CALL NO. 103  
CONTRACT ID NO. 101018  
ADDENDUM # 2

Subject: Jefferson County, IM 0642 (173)  
Letting April 23, 2010

- (1) Revised - Plan Sheets - R2, R2A, R2B, R2C, R2F, R2G, R2J, R2K, R7, R8, R9, R10, R11, R12, R51, & R53
- (2) Revised - Table of Contents - Page 2 of 137
- (3) Added - ITS Notes - Pages 15(a)-15(x) of 137
- (4) Revised - Bid Items - Pages 131-137 of 137

JEFFERSON COUNTY  
TRIMARC RELOCATION ON I-64

COUNTY OF	ITEM NO.	SHEET NO.
JEFFERSON	5-159.10	R51

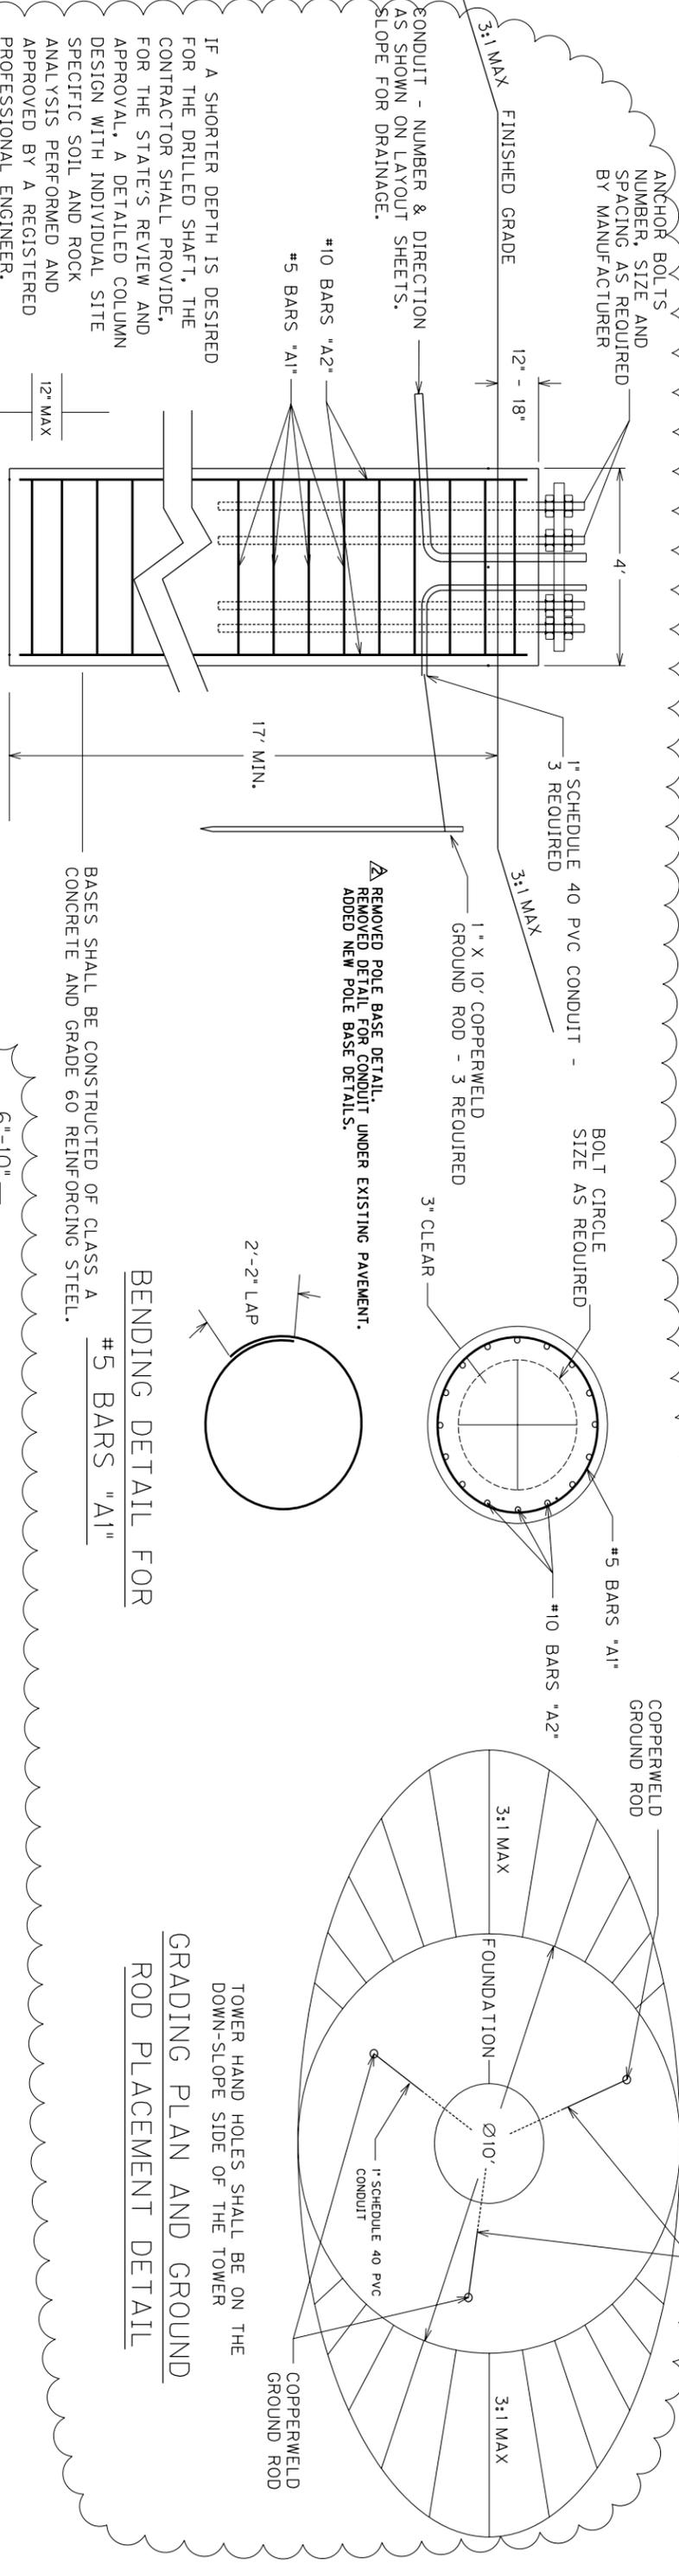
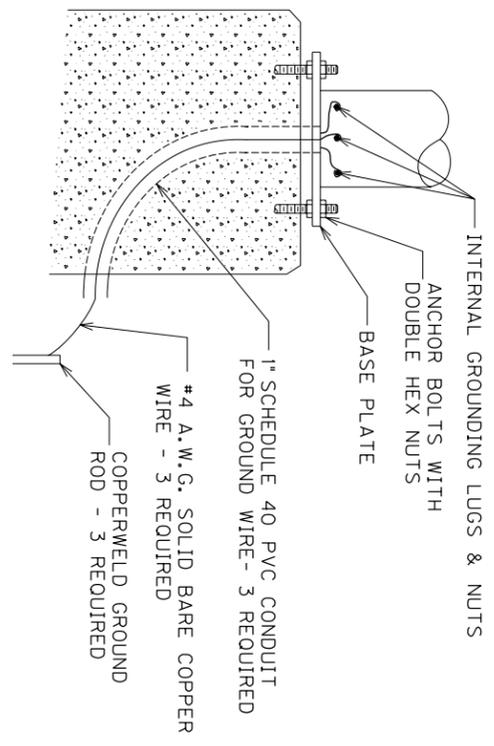
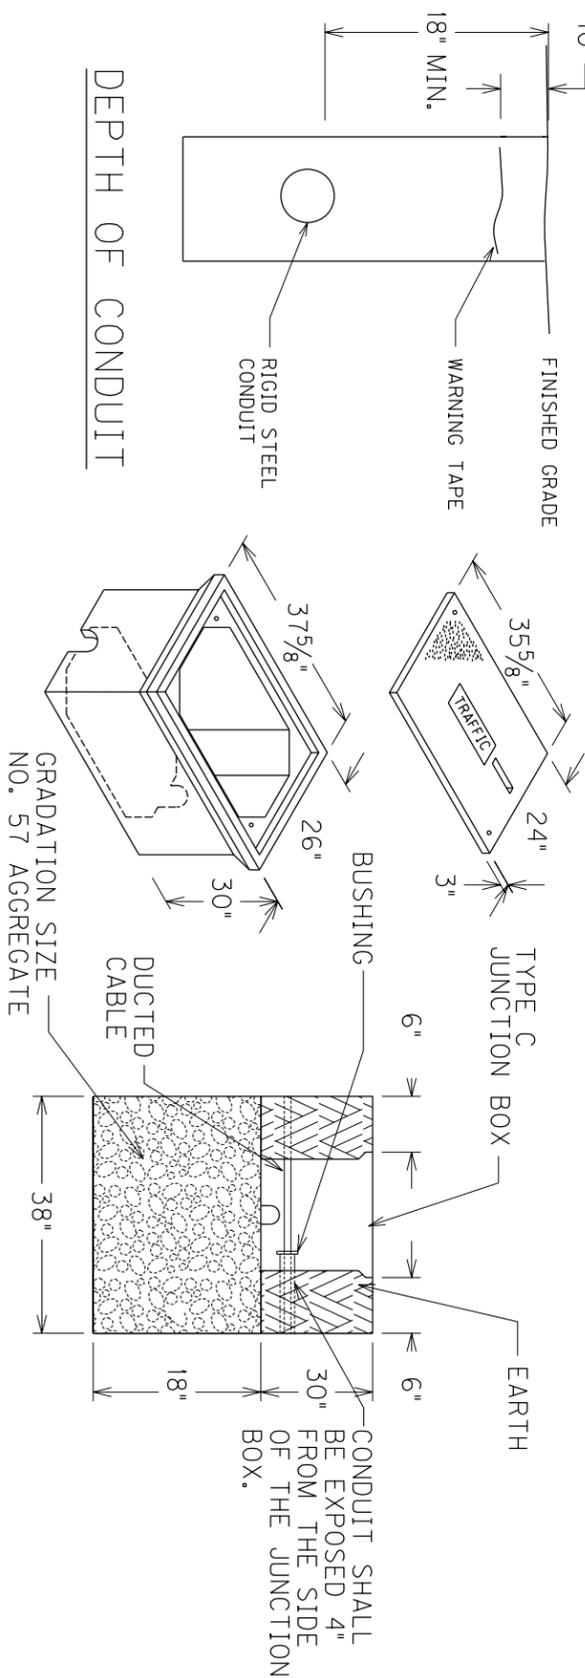
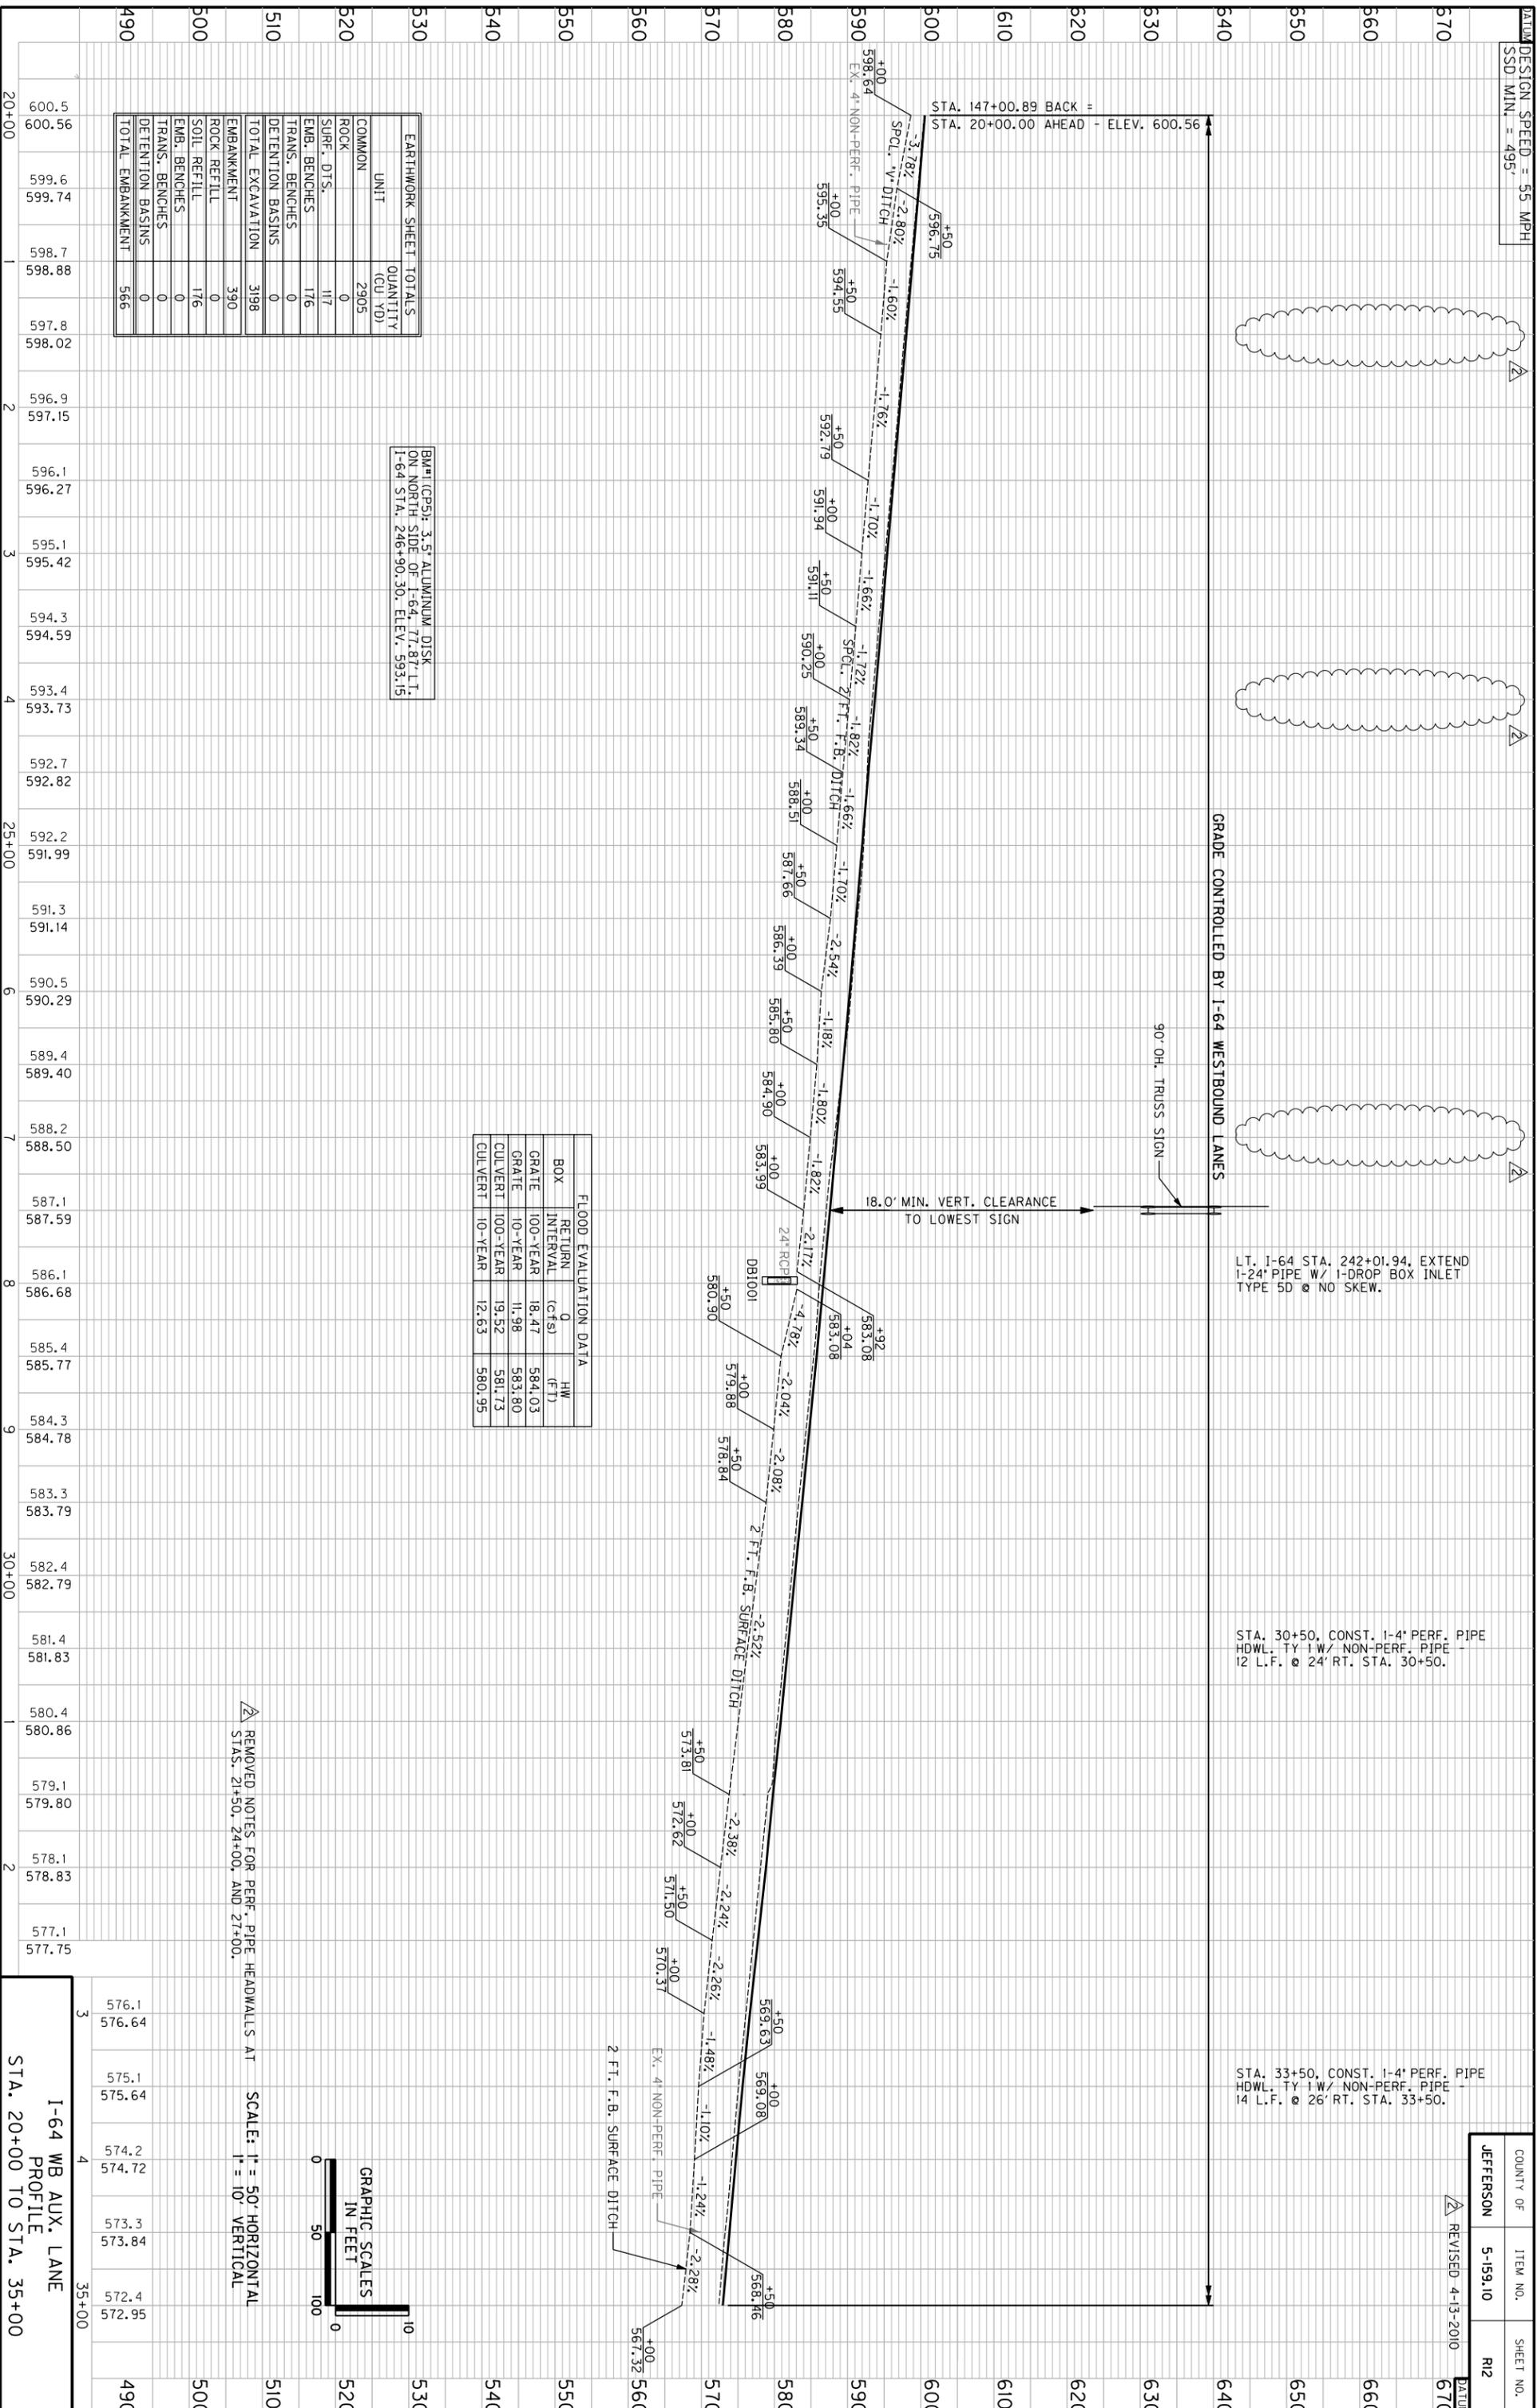
REVISED 4-13-2010

COUNTY OF	ITEM NO.	SHEET NO.
JEFFERSON	5-159.10	R2

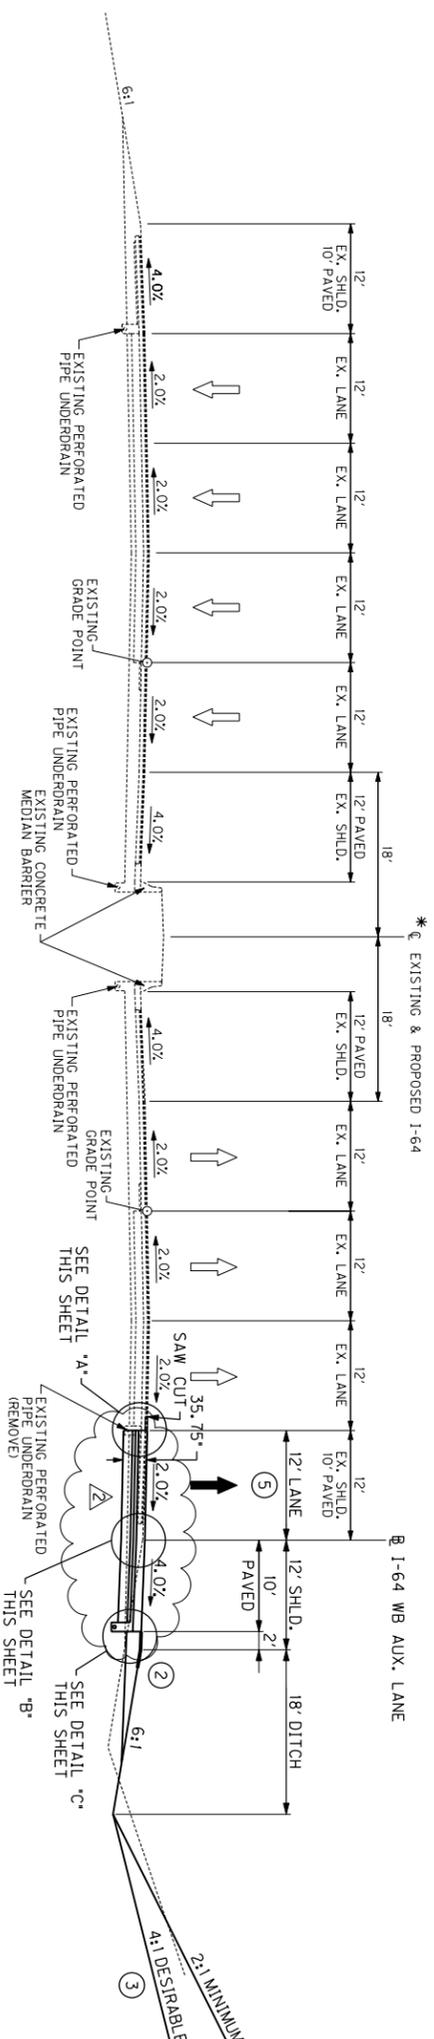
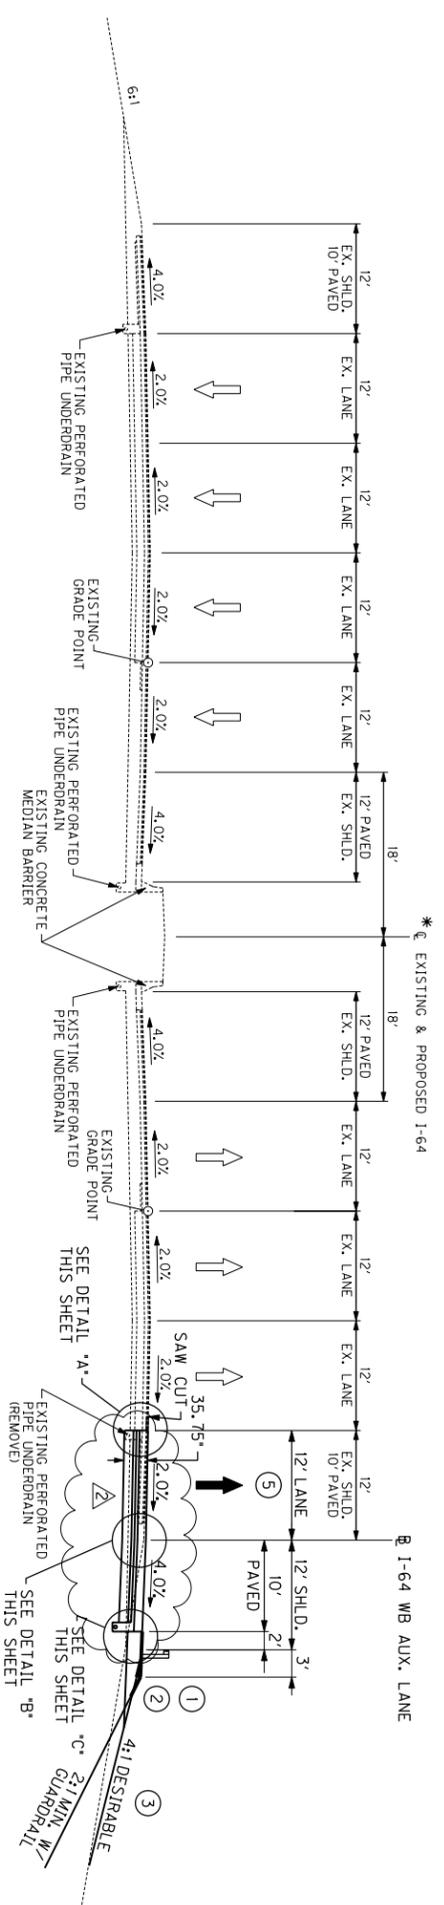
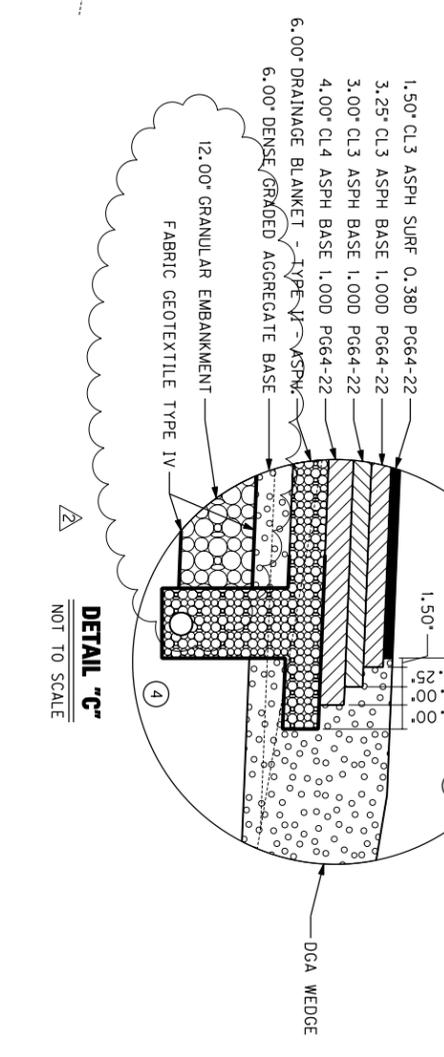
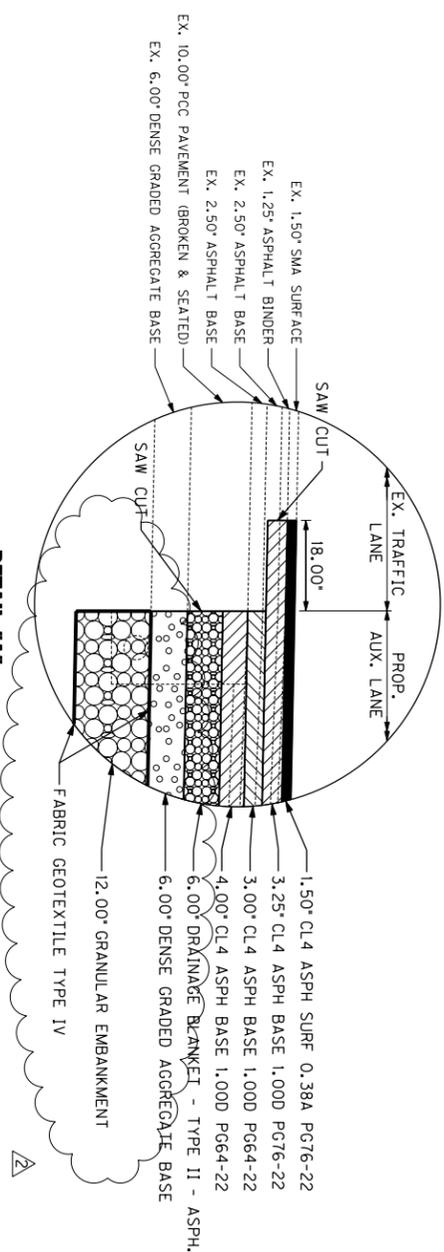
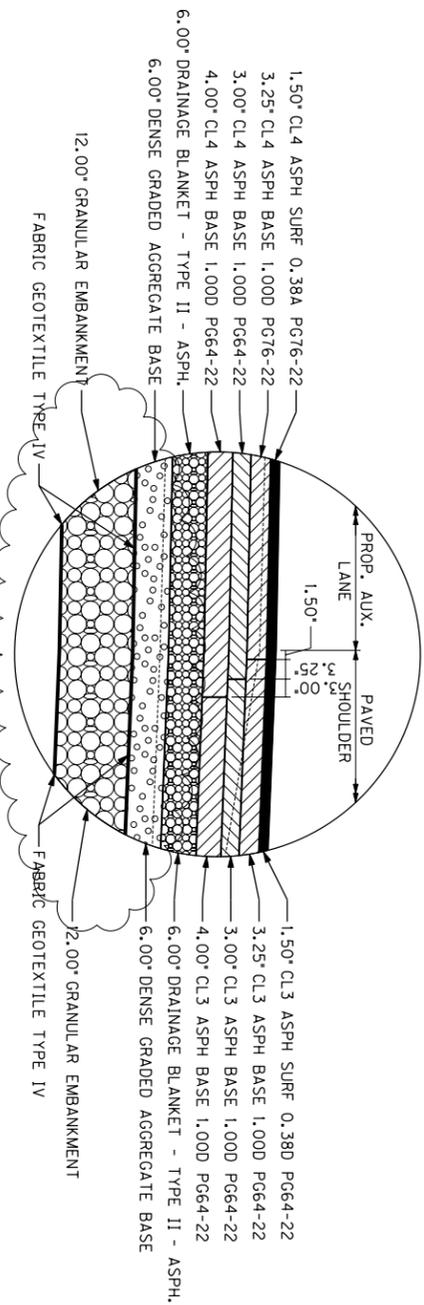
MODIFIED TYPICAL SECTION PAVEMENT DESIGN TO INCLUDE GRANULAR EMBANKMENT
